# UNITED STATES PATENT AND TRADEMARK OFFICE

| APPLICATION NO. | FILING DATE | FIRST NAMED INVENTOR | ATTORNEY DOCKET NO. | CONFIRMATION NO. |
|-----------------|-------------|----------------------|---------------------|------------------|
| 10/776,206      | 02/12/2004  | Tian-Fu Cao          | MR3287-11           | 4173             |

| <b>Office Action Summary</b> | Application No.<br>10/776,206 | Applicant(s)<br>CAO, TIAN-FU |  |

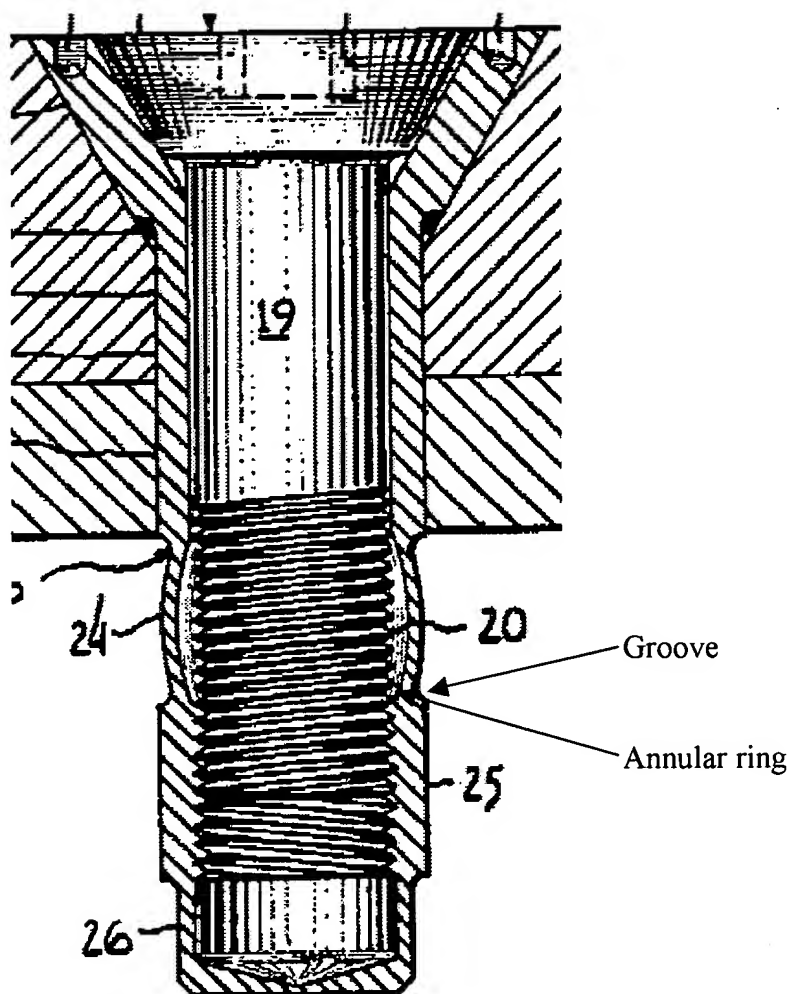
having first (24) and second (25) areas. The first area being closer to the flange and having a greater space then the second area such that an inclined annular ring and peripheral groove (see below) are formed at the same location between the first and second areas. The second area being threaded and a latch (16) is formed adjacent the first area.

Applicant argues that Davis does not disclose a ring portion as indicated in the figure since what is indicated is simply the upper portion of the thread. In response, the examiner disagrees because the arrow in the figure is meant to point to an area

adjacent the first thread but, that notwithstanding, even the surface of the first thread would read on the ring portion since that surface must extend to be larger than the periphery of the threaded surface for the device to be operable.
